DX-NET-SWD3

PowerXL DE1, DC1

**Change Notification due to the launch of the
PROFINET Interface**

1. Edition 2022, publication date 08/22

2.2 'Coast to Stop' (STW1 bit1 & ZSW1 bit4)

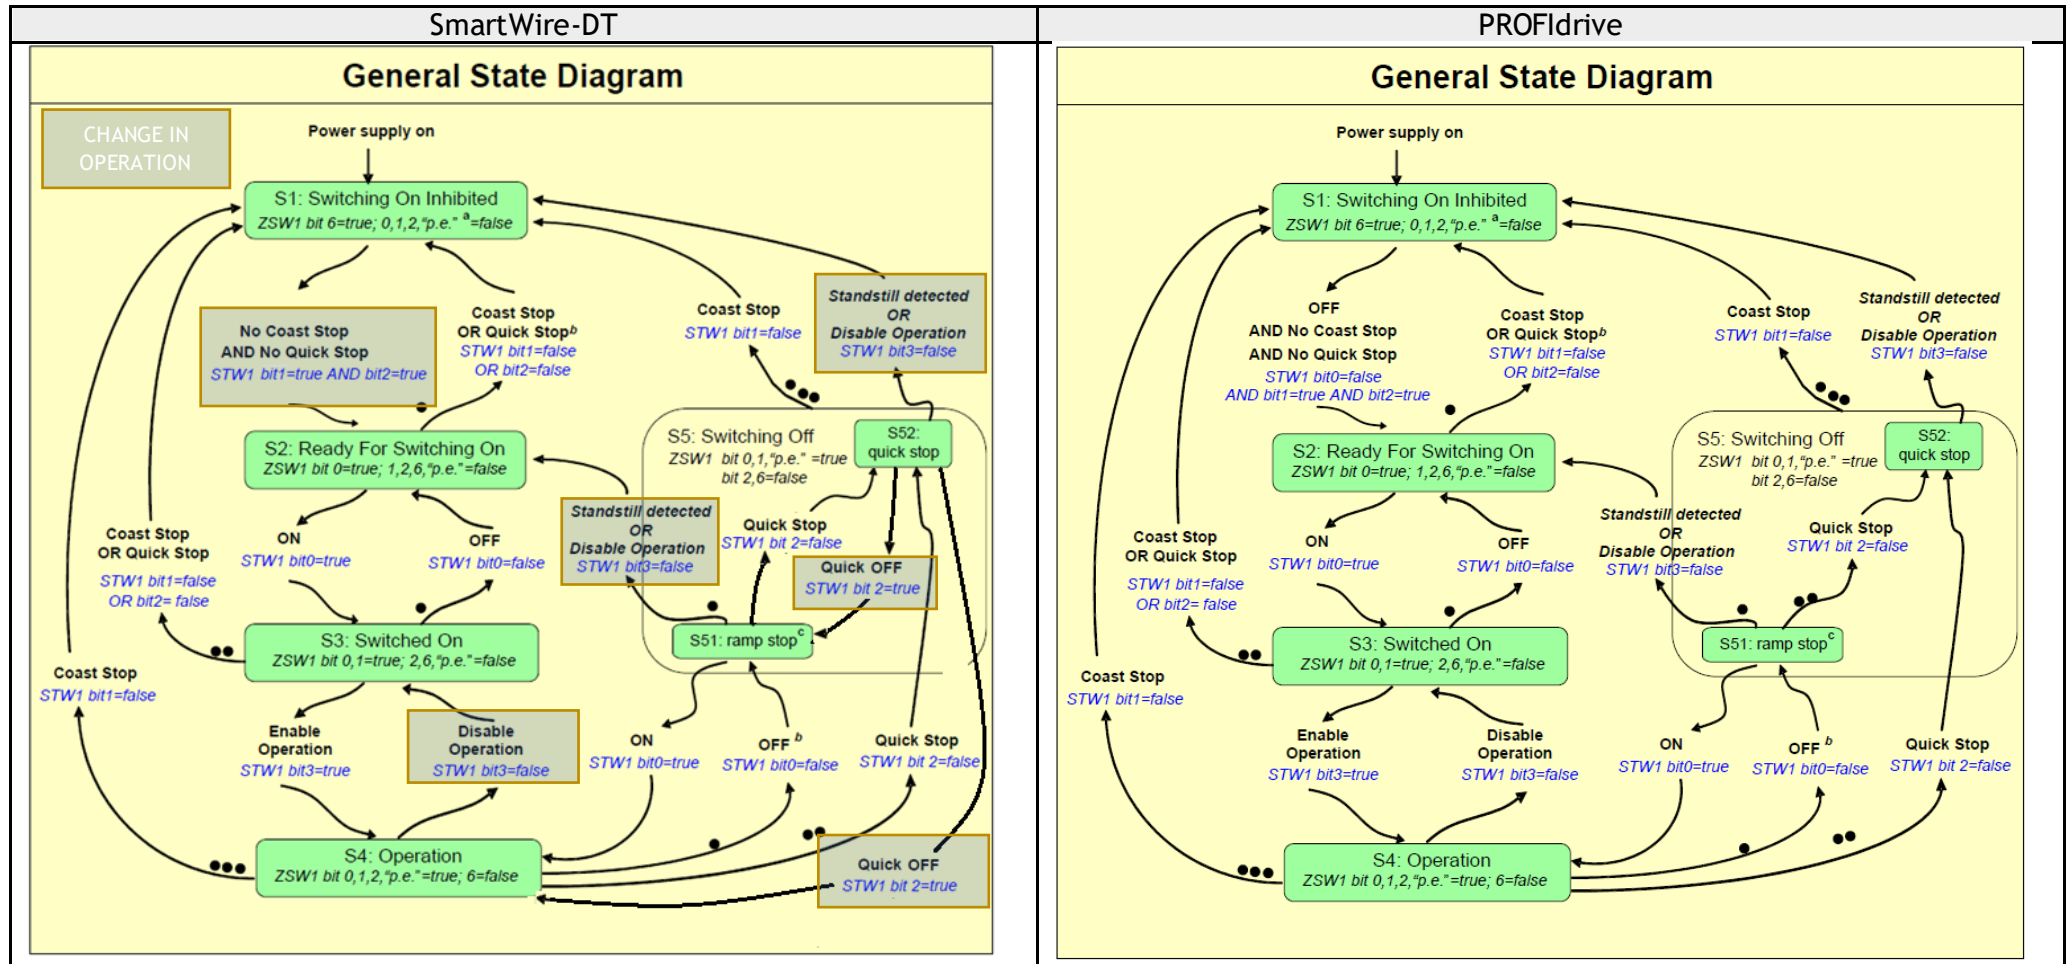
SmartWire-DT	PROFIdrive	Delta	DC1 3ph	DC1 1ph	DE1/DE11
<p>STW1 bit1 0: No coast to stop 1: Coast to stop</p> <p>ZSW1 bit 4 (Coast to Stop) 0: Not Active 1: Active</p>	<p>STW1 bit1 0: Coast to stop 1: No coast to stop</p> <p>ZSW1 bit 4 (Coast to Stop) 0: Active 1: Not Active</p>	<p>Command and status bit logic is inverted</p> <p>SmartWire-DT applications will need to update STW1 bit1 & ZSW1 bit4 logic to transition between states</p>	<p>PROFIdrive operation supported</p>	<p>PROFIdrive operation supported</p>	<p>PROFIdrive operation supported</p>
